Product Change Notice (PCN)

Subject: Bond wire material change for RL78/F13, F14 Series 32pin QFN package products

Publication Date: 3/21/2025

Marking Specification

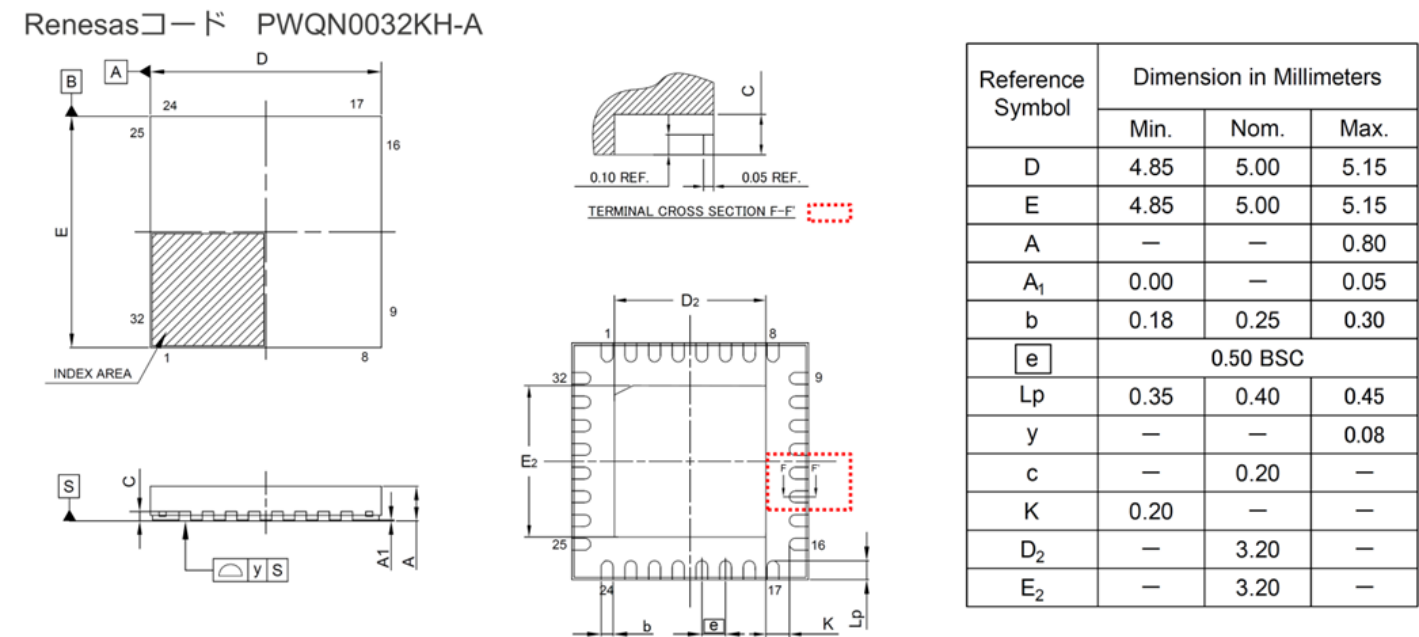
Marking specifications will be changed as follows.

Cu wire Alternate	Au wire Current
RL78/F14 R5F10PBDCKNA#15	RL78/F14 R5F10PBDKNA#G5

Renesasコード PVQN0032KD-A

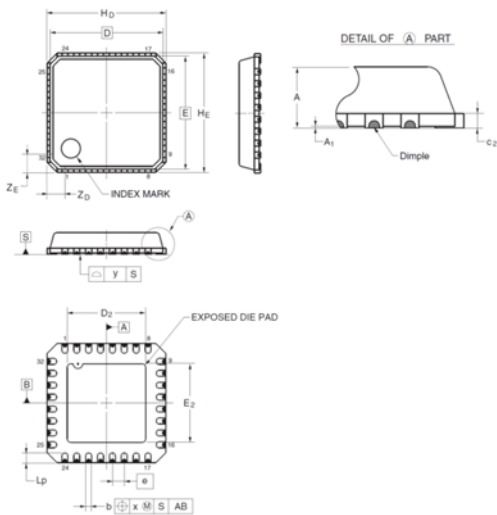
■Package Outline (2/2)

HVQFN with Dimple Wettable flank
Current Au wire

Package Drawing (Dimension comparison)

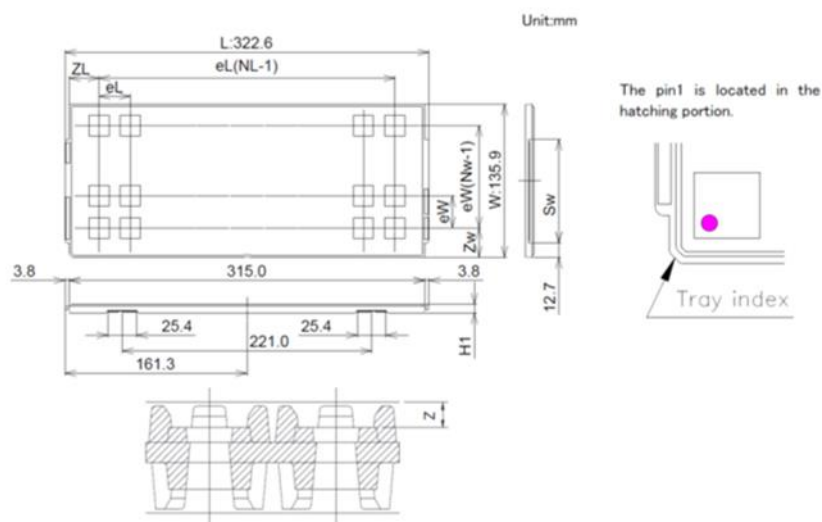
RSKL Symbol New Cu wire	5x5mm 32pin HWQFN PWQN0032KH-A			RSKL Symbol Current Au wire	5x5mm 32pin HWQFN PVQN0032KD-A		
	Dimension in Millimeters				Dimension in Millimeters		
	Min	Nom	Max		Min	Nom	Max
D	4.85	5.00	5.15		-	4.75	-
E	4.85	5.00	5.15		-	4.75	-
A	-	-	0.80	A	-	-	0.90
A1	0.00	-	0.05	A1	0.00	-	-
b	0.18	0.25	0.30	b	0.20	0.25	0.30
	0.50 BSC				-	0.50	-
Lp	0.35	0.40	0.45	Lp	0.30	0.40	0.50
x	-	-	0.80	x	-	-	0.10
y	-	-	0.80	y	-	-	0.05
Hd	-	-	-	Hd	4.95	5.00	5.05
HE	-	-	-	HE	4.95	5.00	5.05
ZD	-	-	-	ZD	-	0.75	-
ZE	-	-	-	ZE	-	0.75	-
c	-	0.20	-	C2	0.19	0.20	0.21
K	0.20	-	-	K	-	-	-
D2	-	3.20	-	D2	-	3.30	-
E2	-	3.20	-	E2	-	3.30	-

Tray Outline Drawing (Renesas Semiconductor KL Sdn.Bhd.)

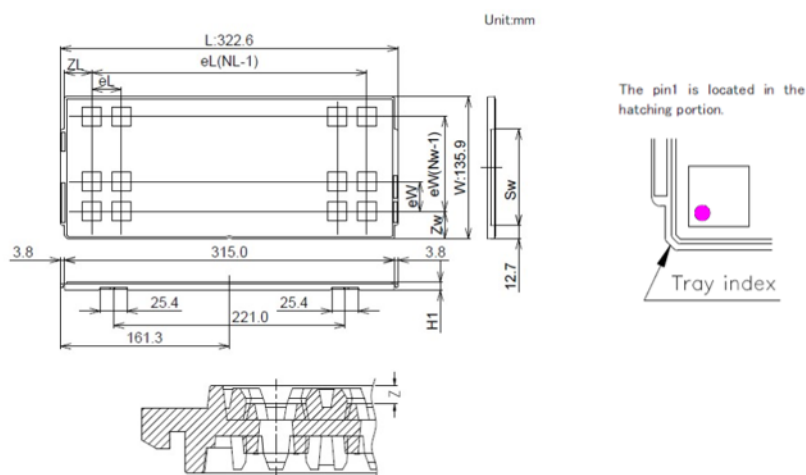
The tray will be changed as follows.

Alternate Cu wire

Tray Code		EAM050501-10
Position dimension of cells	Z	1.75
	Zw	8.15
	ZL	7.90
	eW	9.20
	eL	8.80
Thickness (mm)	Sw	92.1
	H1	7.62
Number of cells	Nw	14
	NL	35
Maximum storage pcs IC/Tray		490
Maximum storage pcs IC/Inner box		3920
Material		Carbon PPE
Heat resistant temperature		135°C MAX
JEDEC or Custom		JEDEC
Surface resistance		Less than $1 \times 10^{11} \Omega/\square$
